ANSI/ASHRAE Addendum y  
to ANSI/ASHRAE Standard 135-2008

## BACnet<sup>®</sup> — A Data Communication Protocol for Building Automation and Control Networks

### **135-2008y-1. Specify Deployment Options for MS/TP, p. 2.**

**Figure 9-1.1.** Simple Twisted Pair with Shield.

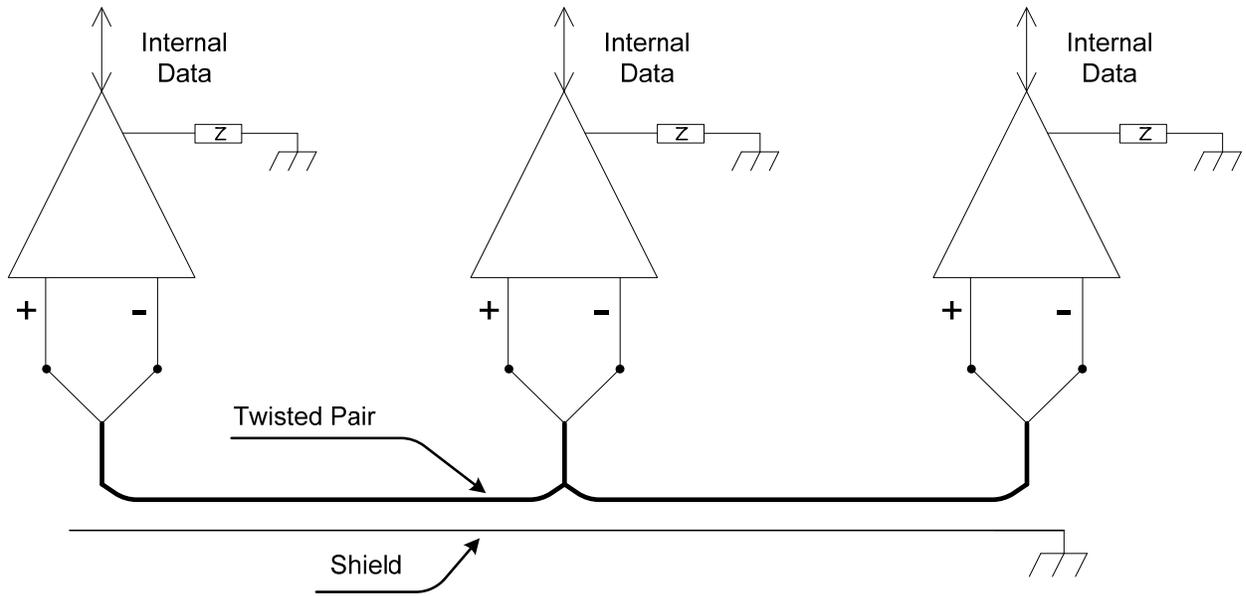
For many installations, a simple twisted pair wire with shield is sufficient to allow reliable communications. In Figure 9-1.1, all of the devices use two-wire connections with the reference level between devices established by an internal earth ground connection made through some impedance ( $Z$ ) at each device. This is generally the lowest cost solution and is sufficient for installations where electrical noise, ground noise, and stray fields are low. EIA-485 is designed to operate with voltages on the signaling wires between -7 and +12 volts. If the voltage between any two earth ground connections combined with the noise picked up by the twisted pair signaling wire is well within this range, the EIA-485 requirements for signaling levels have been met.

**Figure 9-1.2.** Mixed Devices on Twisted Pair with Shield.

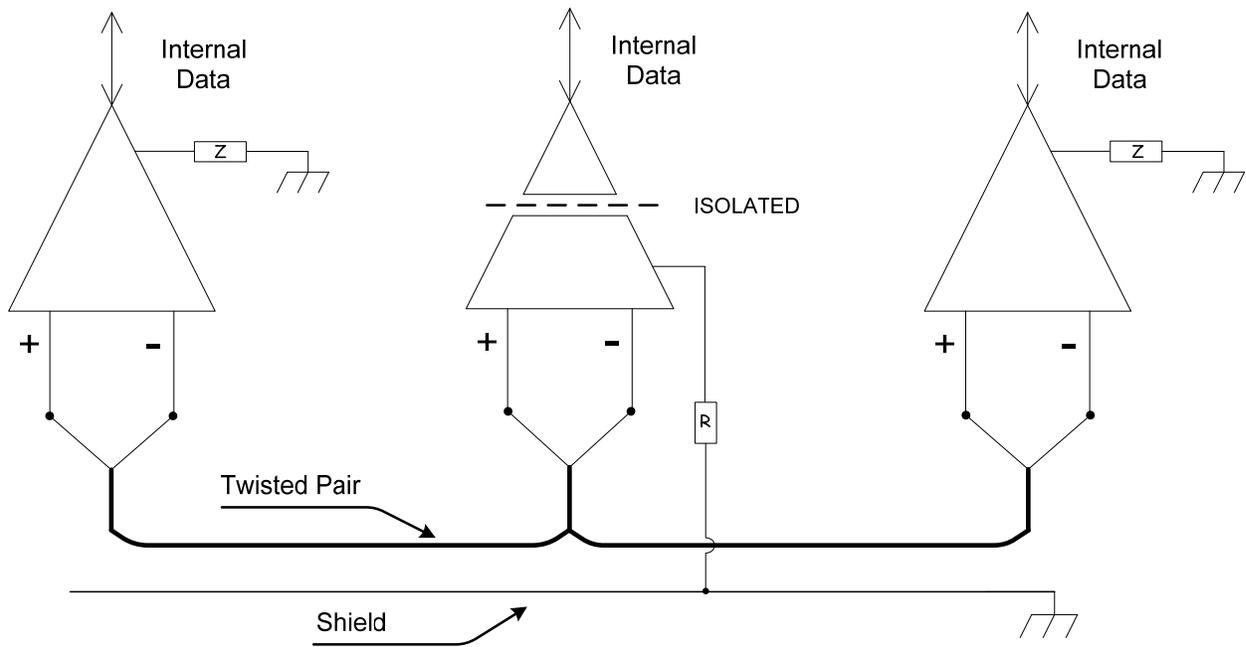
Some EIA-485 devices provide a third-wire reference connection and use internal isolation. The third-wire reference shall be electrically connected to the other devices' reference to meet EIA-485 requirements. When such a device is used in a low-electrical-noise installation, it is sufficient to connect the third-wire reference to earth using a 100 ohm current limiting resistor (R) as shown in Figure 9-1.2. The earth connection may be made using either the shield of the communication cable since it is tied to earth ground at one point (this is the preferred approach) or a local earth grounding point such as the device case. This type of connection does not take full advantage of the electrical noise rejection capability of the third-wire reference.

**Figure 9-1.3.** All Isolated Devices on 3-Conductor Cable with Shield.

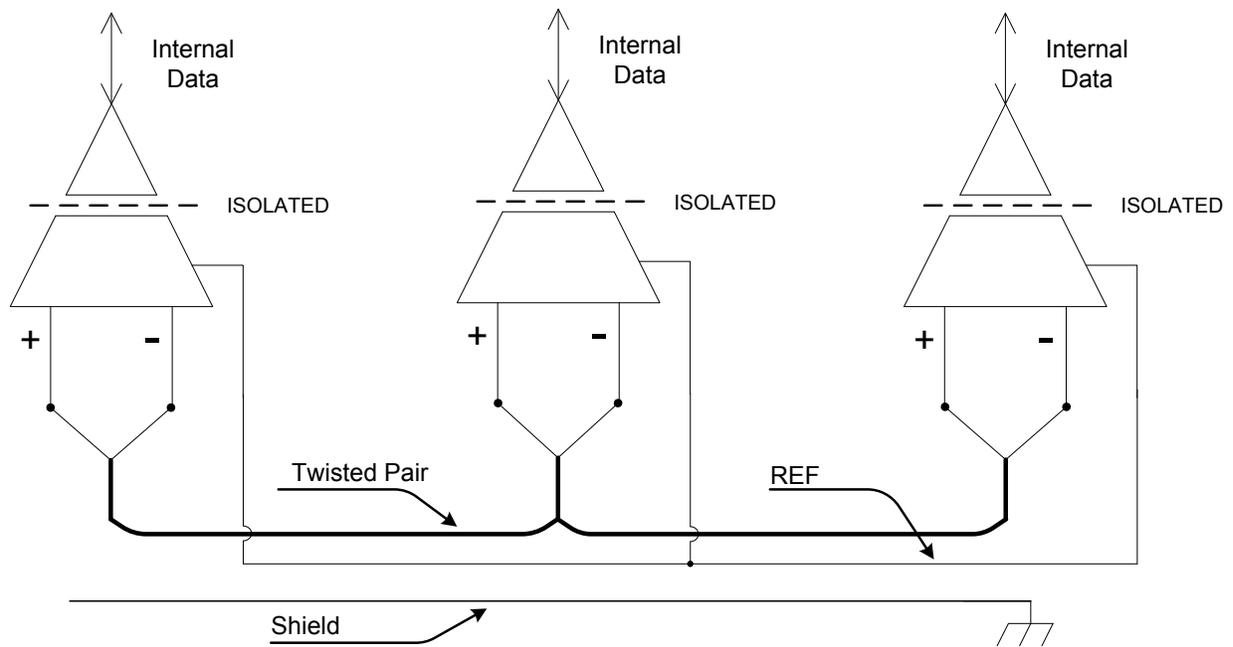
If the installation exclusively uses EIA-485 devices with third-wire reference connections, electrical noise rejection is best if a third conductor in the same cable is used to connect all of the reference connections together as shown in Figure 9-1.3. This nearly eliminates earth-ground voltage differences and allows the differential input of each EIA-485 device to float with the electrical noise and stray fields picked up by the signal cable, resulting in better noise rejection. If there are more than three wires in the cable chosen, the third conductor shall be made up of all of the extra wires (outside of the twisted pair used for signaling) connected together. If desired, the third-wire reference conductor may be tied to earth ground at one point where electrical noise is low through a 100-ohm current-limiting resistor in order to limit voltage excursions and to simplify adding two-wire devices in the future.

**Figure 9-1.4.** Mixed Devices on 3-Conductor Cable with Shield.

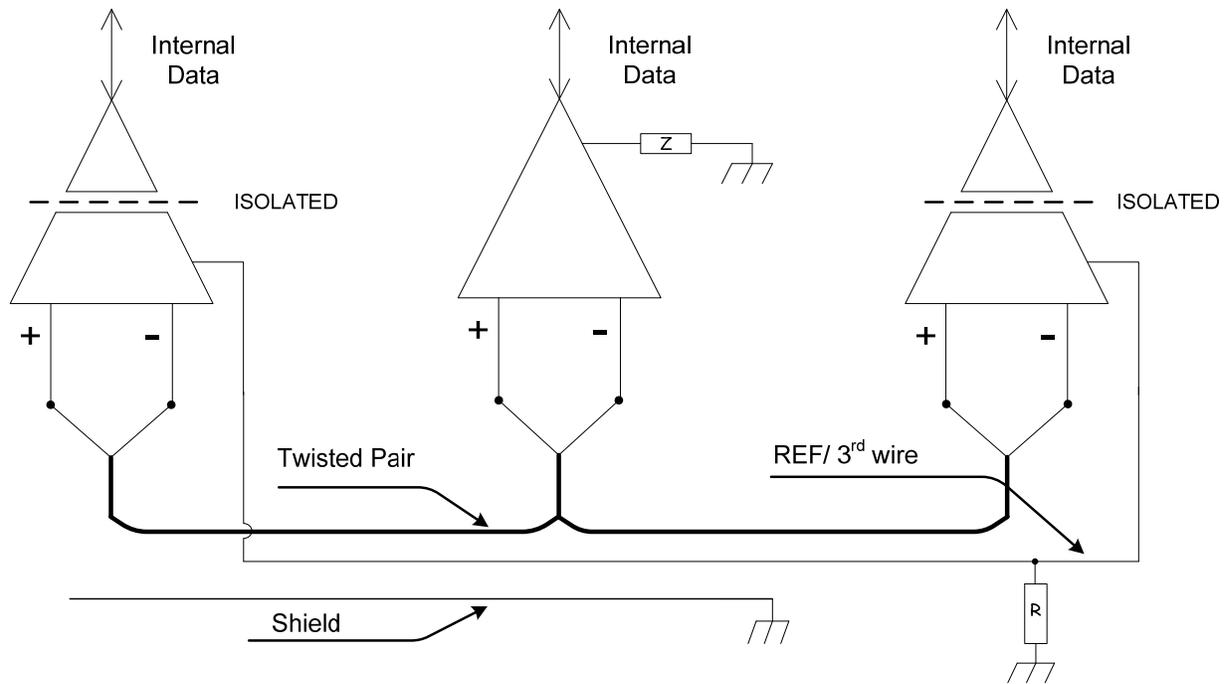
If the installation includes a mixture of two-wire non-isolated devices and three-wire isolated devices, they may be used together in the configuration of Figure 9-1.4 if the two-wire devices are installed in areas with low electrical noise or if high levels of electrical noise are generated locally at the three-wire isolated devices and the remainder of the installation is electrically quiet. In this installation, a third conductor in the same cable is used to connect all of the reference connections together. Three-wire devices with a reference connection shall be directly tied to the third conductor and two-wire device reference connections are made indirectly through a single 100-ohm current-limiting resistor tied between the reference conductor and earth ground in a low-noise area, preferably near the supervisory controller.

**Figure 9-1.5.** Extending Existing Twisted-pair with Isolated Devices.

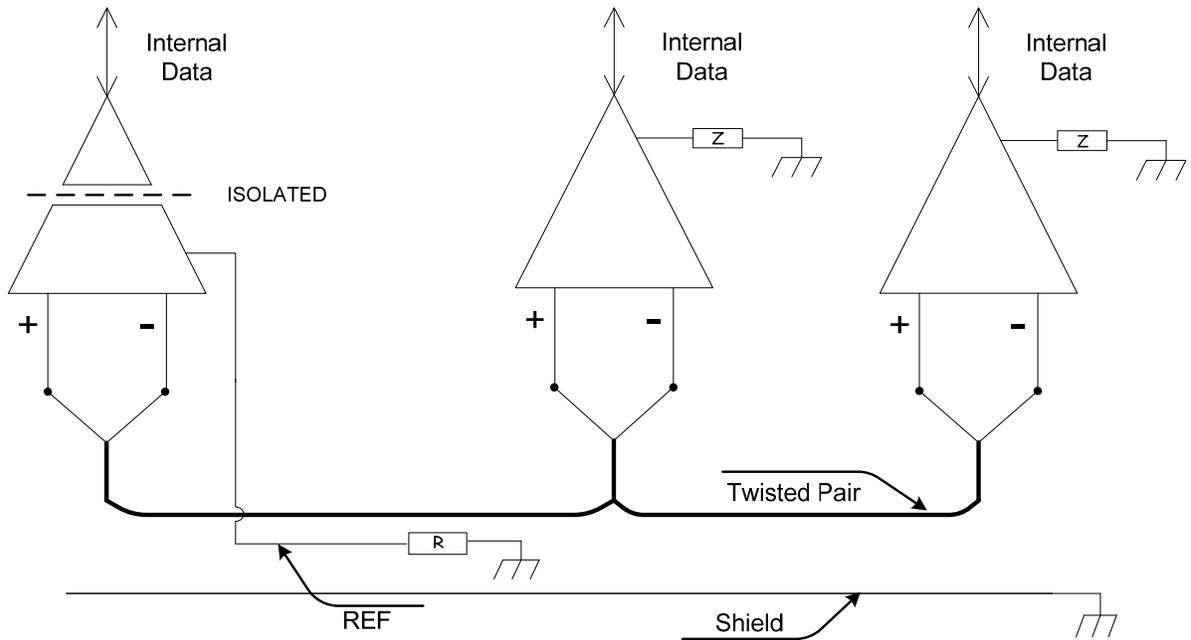
If the installation includes existing two-wire non-isolated devices that are to be extended with three-wire isolated devices, they may be connected together in the configuration of Figure 9-1.5. In this installation, a third conductor in the extended cable is used to connect all of the reference connections together. Three-wire devices with a reference connection shall be directly tied to the third conductor and two-wire device reference connections are made indirectly through a single 100-ohm current-limiting resistor tied between the reference conductor and earth ground in a low noise area, preferably where the extended cable is connected to the existing twisted-pair cable.

**Figure 9-1.6.** Two Buildings with All Isolated Devices in One Building.

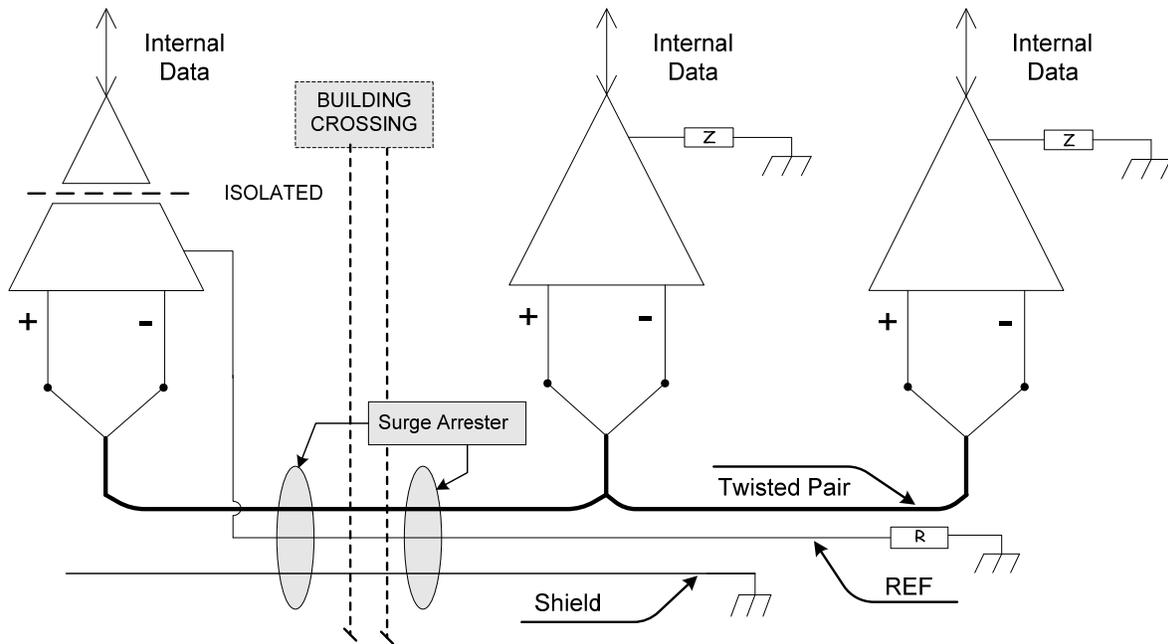
Installations that connect multiple buildings using a single cable are permitted if the secondary buildings contain only three-wire isolated devices with 1500-volt electrical isolation capability and there are no earth ground connections in the secondary buildings to the reference conductor or the shield as shown in Figure 9-1.6. When the primary building contains only two-wire non-isolated devices, the reference conductor shall be connected to earth ground at one location through a 100-ohm current-limiting resistor (R) in that building and the shield shall be tied to earth ground in a single location in the same building. The use of surge arrestors near each building's cable entrance to protect all of the conductors is recommended.

**Figure 9-1.7.** Isolated Repeater between Two Buildings with Surge Arresters.

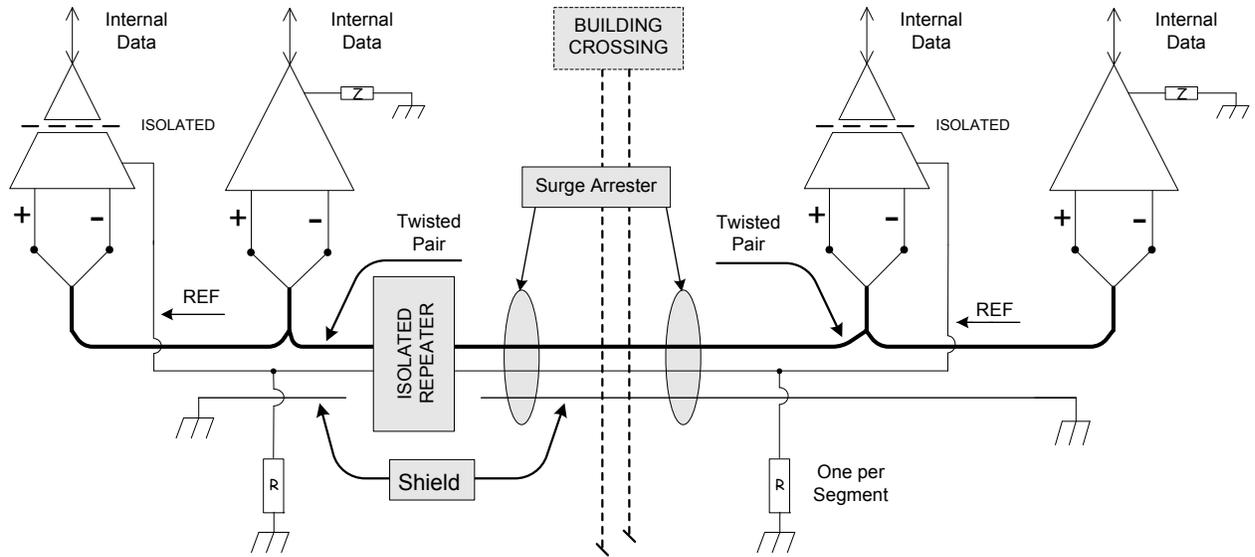
If the installation includes a mixture of three-wire isolated and two-wire non-isolated devices in each of two buildings on a single communications line, it is possible to connect the buildings using an isolated repeater so that each building is electrically isolated from the other building as shown in Figure 9-1.7. The isolated repeater must provide complete three-way electrical isolation between the wiring on either side and ground. In this case, the communication wiring within each building is configured like that of a single building since the isolated repeater provides the required 1500-volt electrical isolation. The cable connecting the buildings is an extension of the cable in one of the buildings and shall be electrically isolated from the other building by the isolated repeater and shall not have any connections to other devices or to ground within the other building.

An isolated repeater may also be used on both sides of the cable connecting the buildings. This may be needed for extra isolation or for cable length. In this case the cable connecting the buildings shall be separately shielded, terminated, and biased and shall not have any connections to other devices within either building. If the pair of isolated repeaters provides a reference connection, the two reference connections shall be joined by a third conductor within the cable connecting the buildings and shall not be connected to any other device or to ground.

The use of surge arrestors near each building's cable entrance to protect all of the conductors is recommended.

**Figure 9-1.8.** Fiber Optic Modems between Two Buildings.

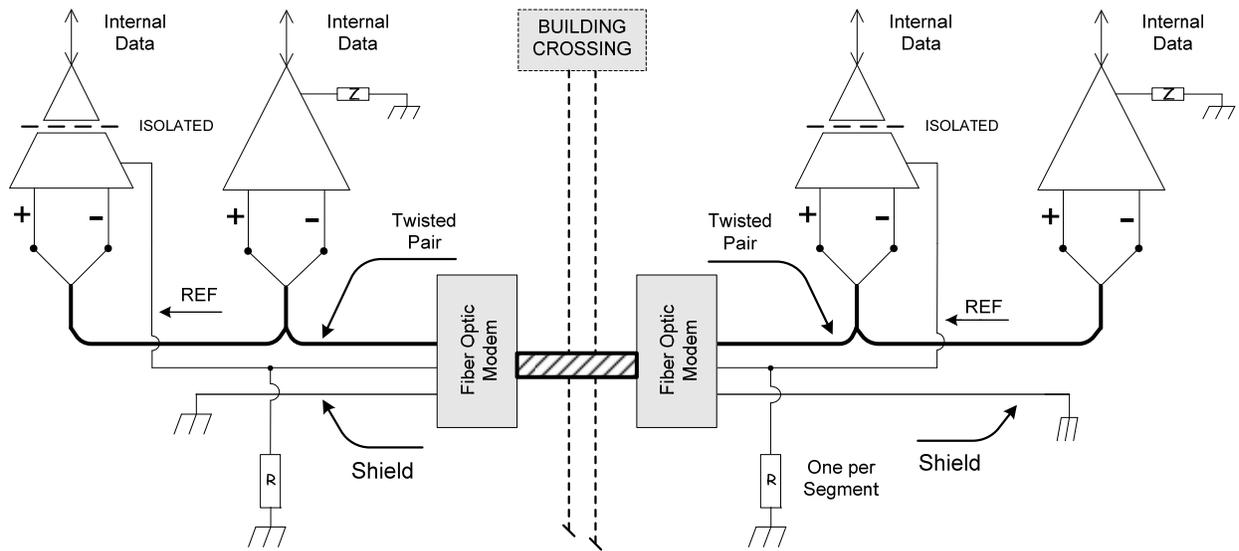
If the installation includes a mixture of three-wire isolated and two-wire non-isolated devices in each of two buildings on a single communications line, it is best to connect the buildings using EIA-485 half-duplex compatible fiber optic modems so that each building is electrically isolated from the other building and there are no conductors outside the buildings as shown in Figure 9-1.8. In this case, the communication wiring within each building is configured like that of a single building since the fiber optic modems provide the required 1500-volt electrical isolation.

**Figure 9-1.9.** Two Buildings with Mixed Devices – No Isolation (Not Allowed).

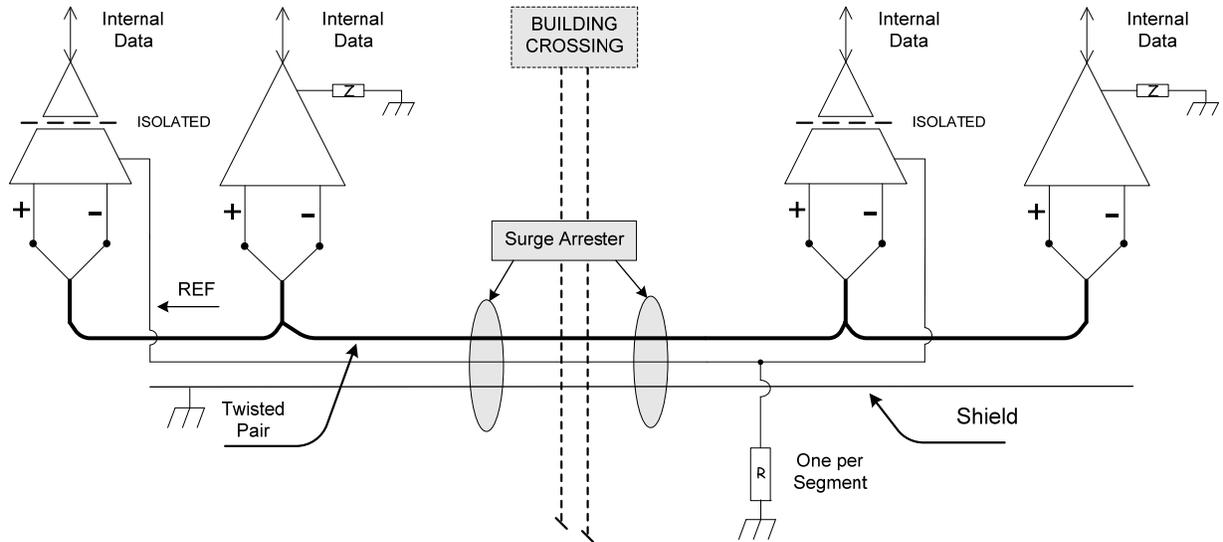
Directly connecting two buildings with a single EIA-485 communications cable where there are two-wire non-isolated devices in each building shall not be permitted since the required 1500-V electrical isolation between signal conductors and digital ground cannot be maintained. Device wiring such as that shown in Figure 9-1.9 is not allowed.
